CHANGE ORDER REQUEST

JOB #:101520
MOD #: 0005 -00
DATED: 10/15/10

RE: Neenah Menasha Fire
Rescue Station 36
1108 Province Terrace
Menasha WI 54952

Report of Subgrade Preparation Observations

APPROXIMATE FIELD TESTING LOCATIONS DIAGRAM	Scale: 1" = 40'
	Project No:
MENASHA FIRE STATION MANITOWOC ROAD MENASHA, WISCONSIN	Date: 10/14/10
	Drawn By: KP

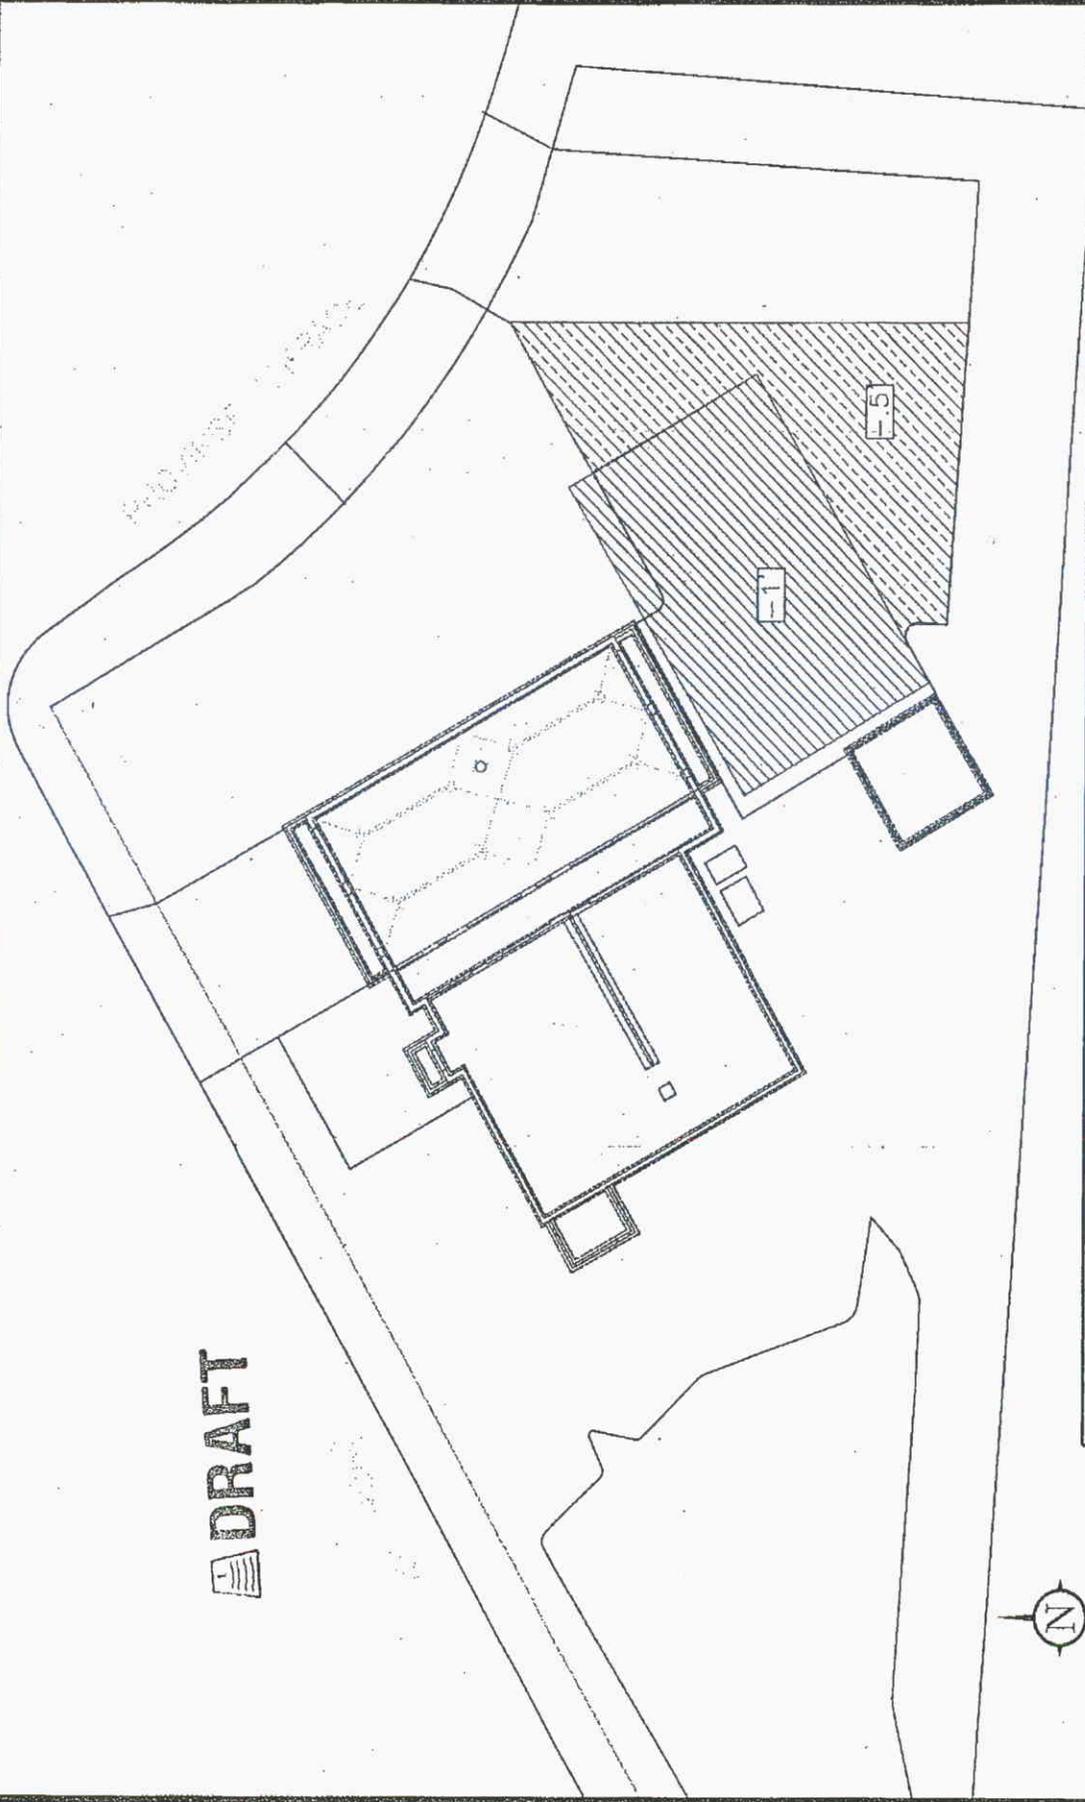
Major rolling and rutting was observed during proofroll in a area 50'x80'. MES recommended removing 1' of material and replacing it with compacted 3 inch breaker. Minor rutting and rolling was observed within the remaining area of the parking lot. Within this area, MES recommended removing 6 inches of material and replacing it with compacted 3 inch breaker. It is also recommended that fabric be placed prior to placing stone.

Remove and replace unsuitable soils at asphalt parking area per MES Soils Engineer recommendation. Also provide segregation fabric. Use unit prices.
